Appendix I of RNTPC
Paper No. A/HSK/477

Proposed Temporary Reinforcing Steel
Processing Workshop with Ancillary Office
for a Period of 3 Years at Lot 1262(Part)
in D.D. 124, Ha Tsuen, Yuen Long

Technical Support For The Proposed Temporary Reinforcing Steel Processing Workshop With Ancillary Office For A Period Of 3 Years
At Lot 1262 (Part) In D.D. 124, Ha Tsuen, Yuen Long

Responses to Comments from Drainage Services Department (A/HSK/230)

**PROPOSED
DRAINAGE
PLAN
FIGURE 3.1**

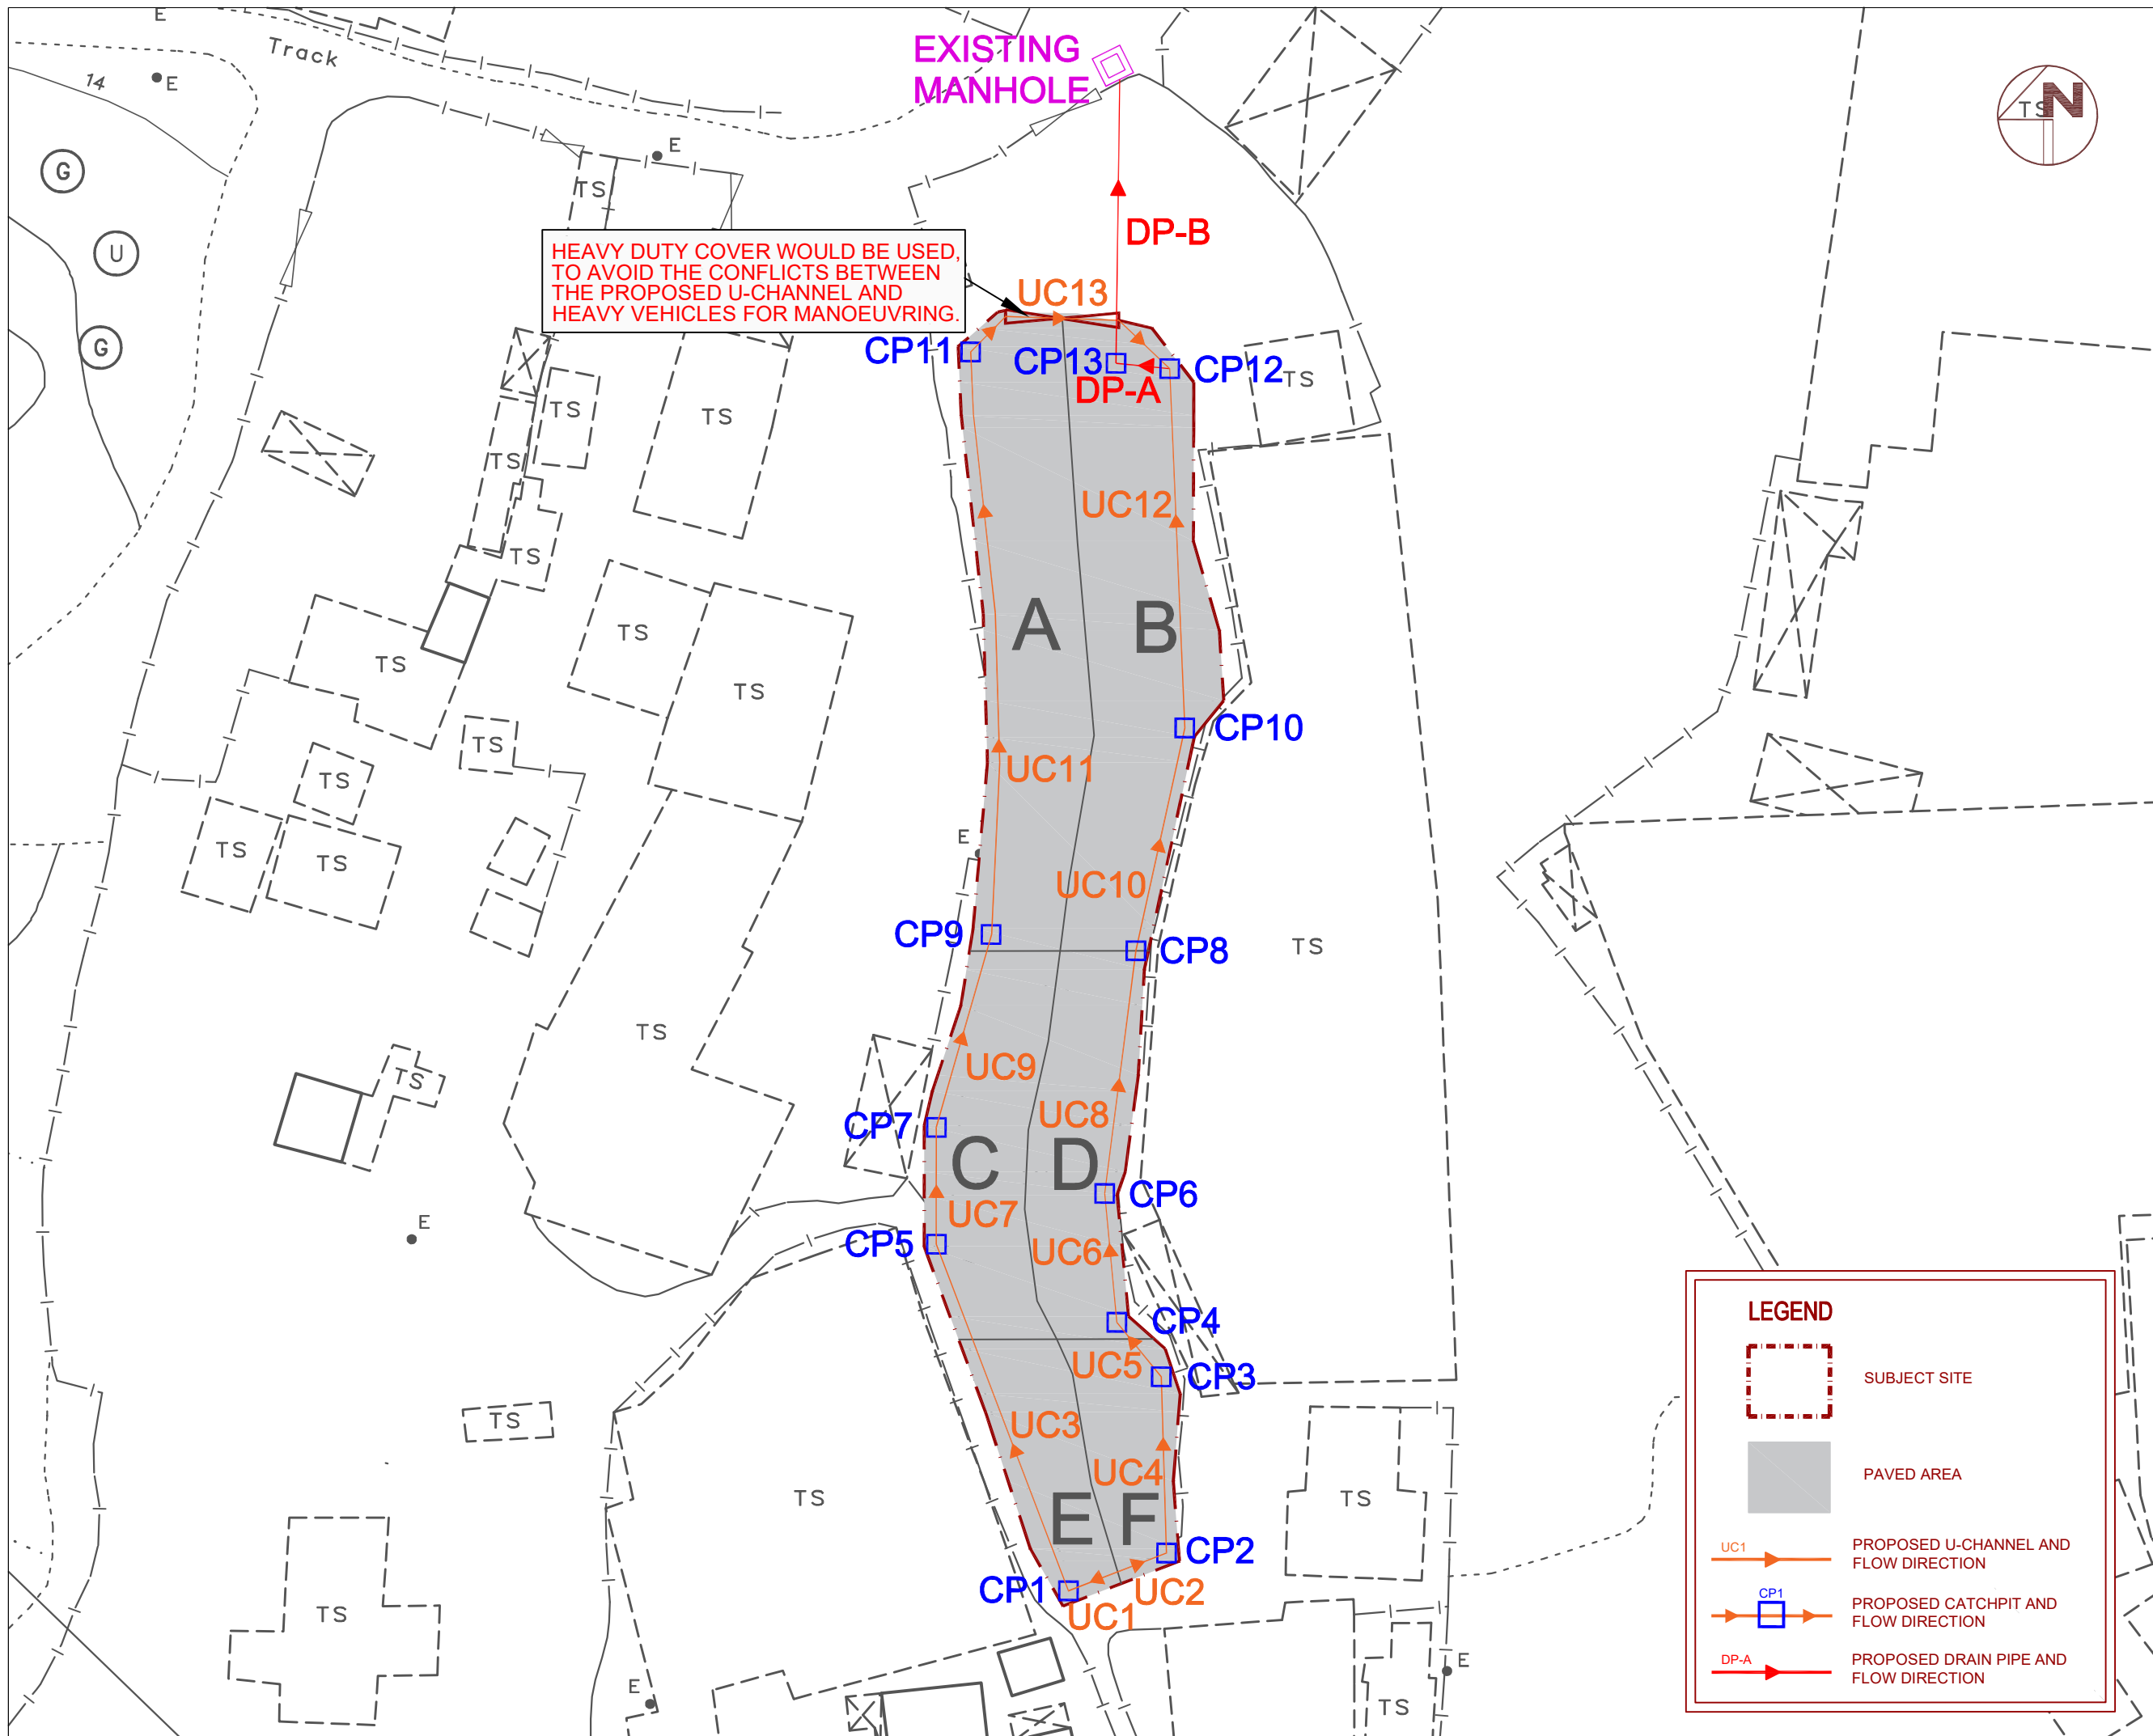
f. Sand trap or provision alike should be provided before the collected runoff is discharged to the public drainage facilities;	As can be seen in Figure 3.1 of the Drainage Proposal, catch pits complete with sand traps will be provided for the application site. Construction of catch pits that include sand traps will take place in accordance with the standard drawings provided by the CEDD and can be found in Annex 3 of the Drainage Proposal.

Typical Design of U-channel and Catchpit

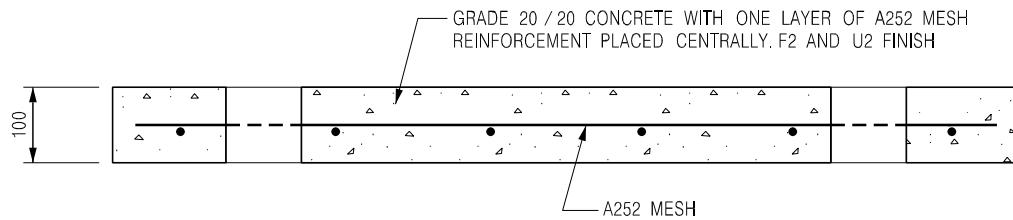
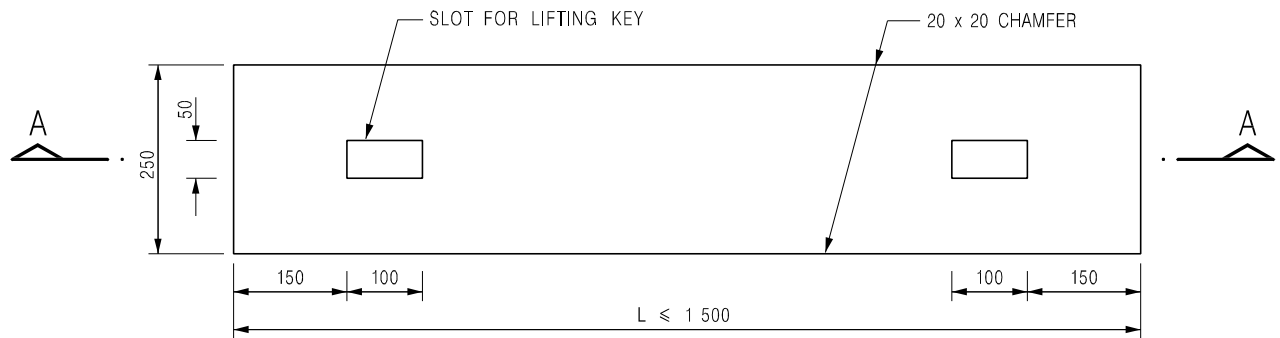
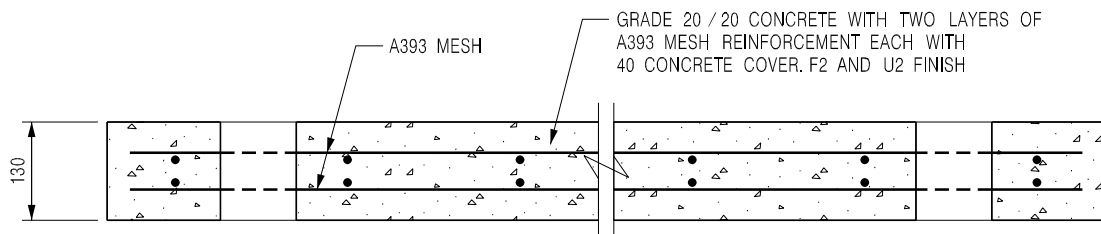
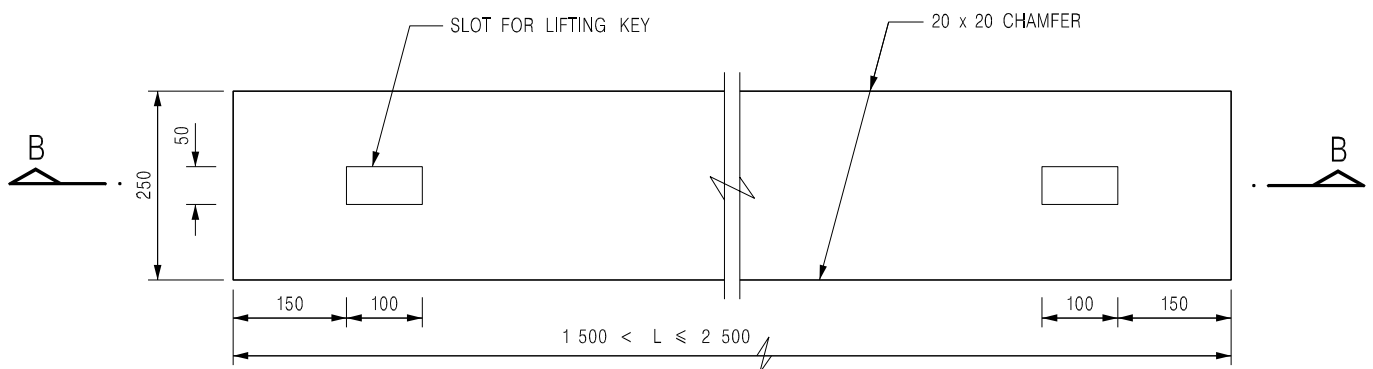
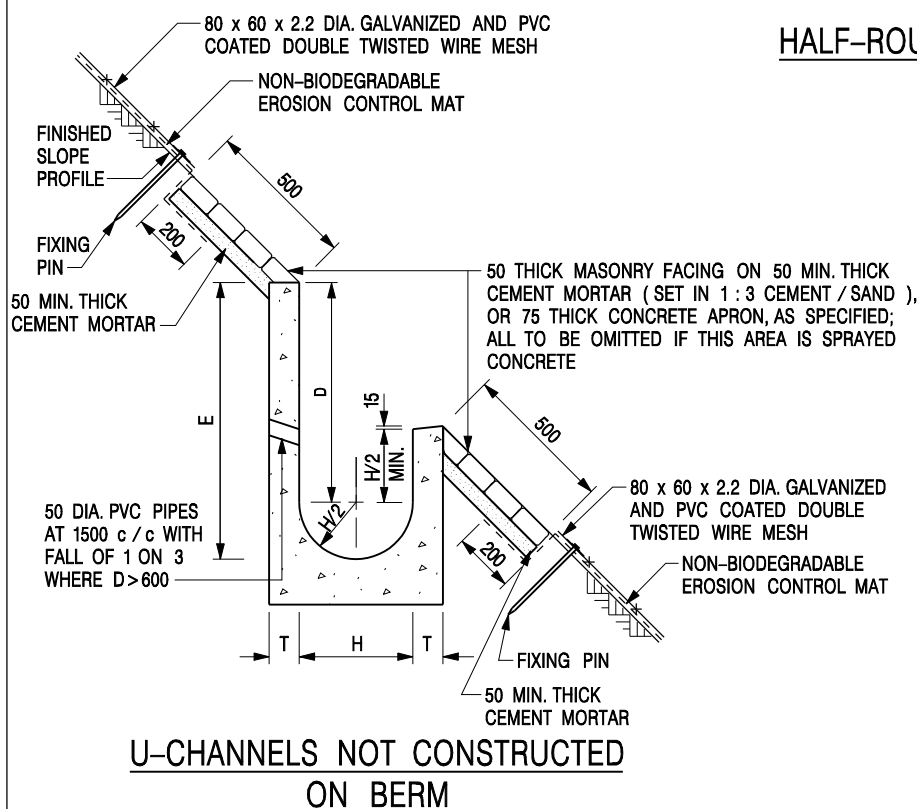
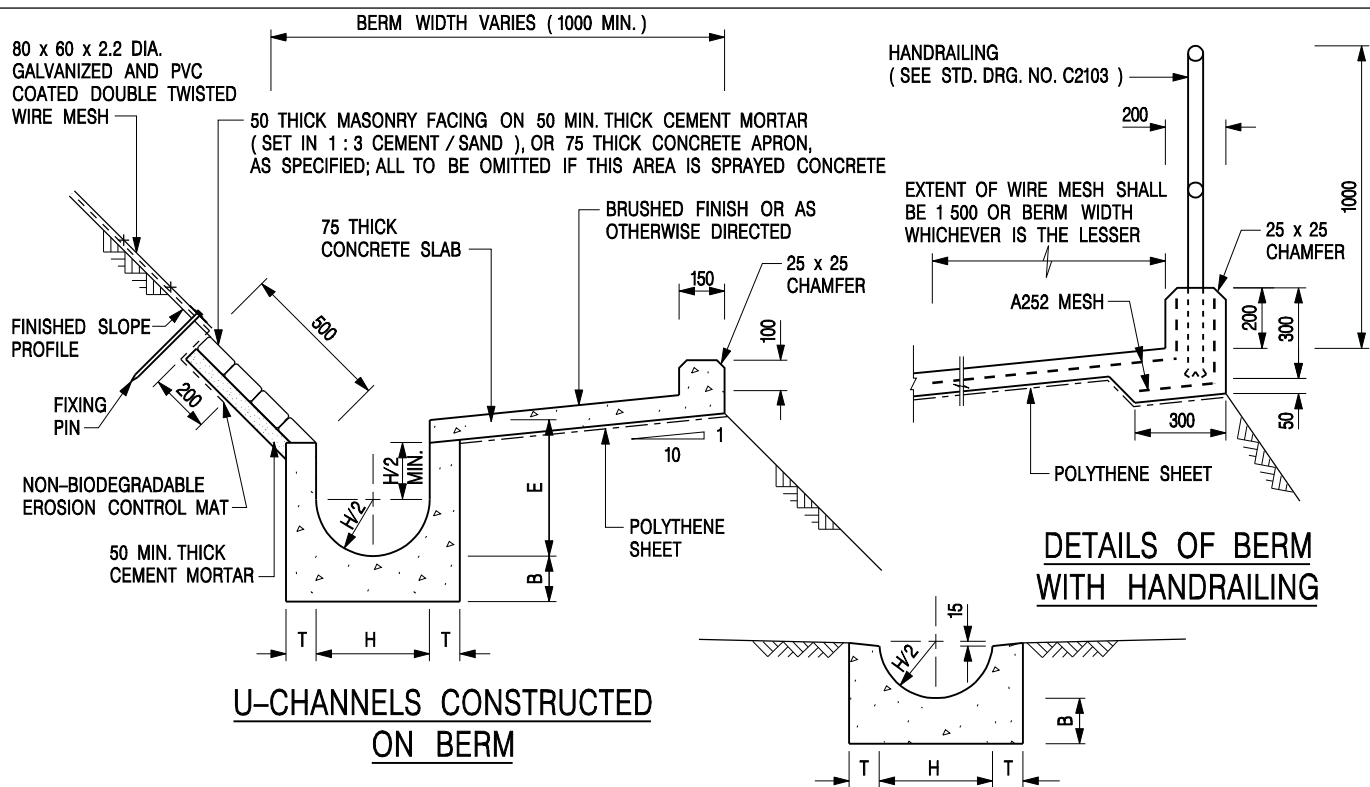
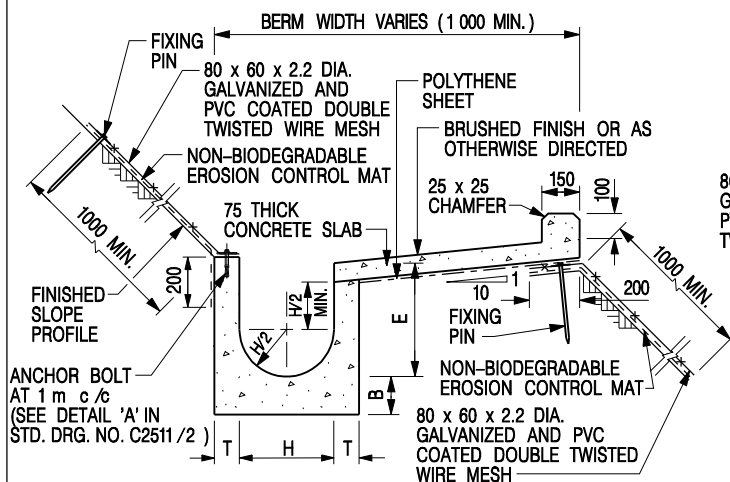
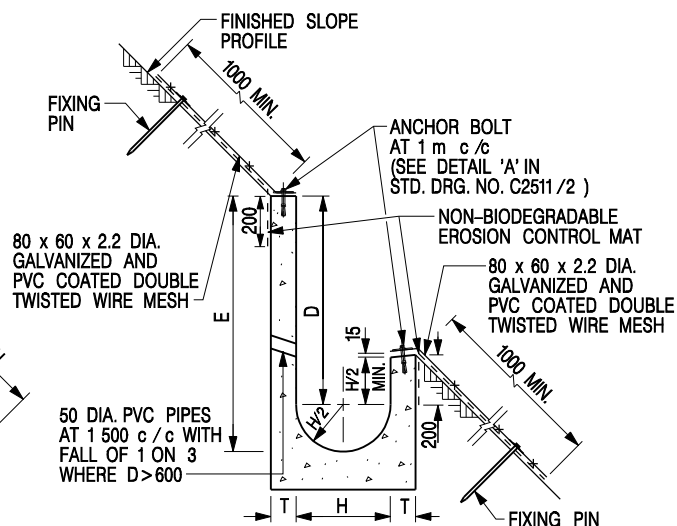
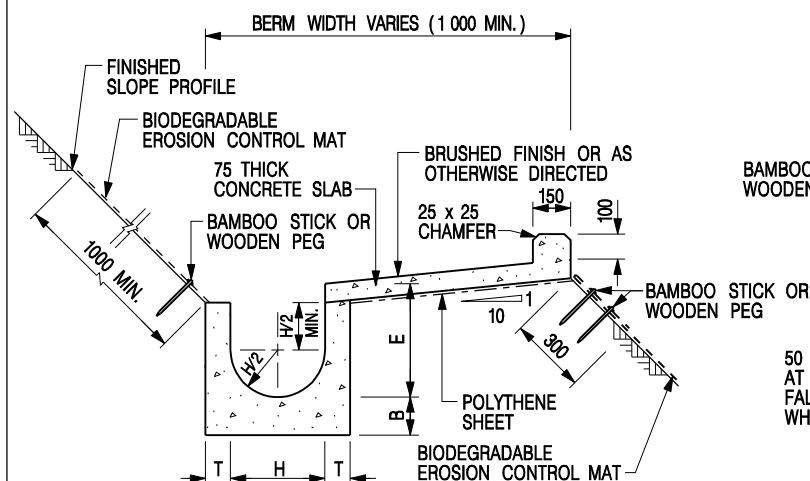
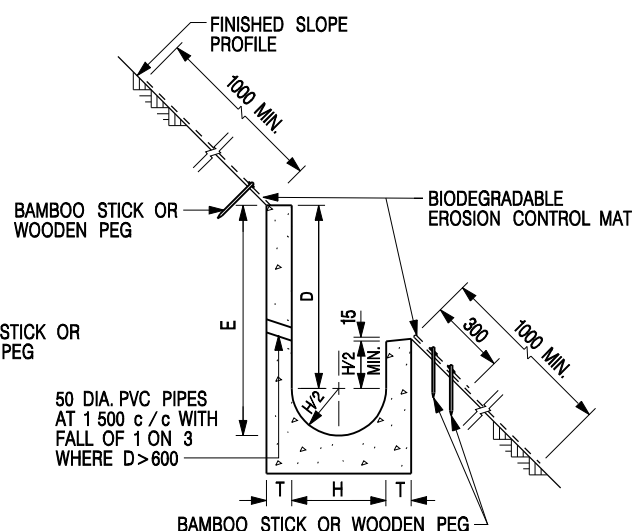
g. Standard details should be provided to indicate the sectional details of the proposed u-channel and the catch pit/sand trap;	All u-channels, catch pits & manhole will be constructed according to the CEDD's standard drawings, as illustrated in Annex 3 of the Drainage Proposal.
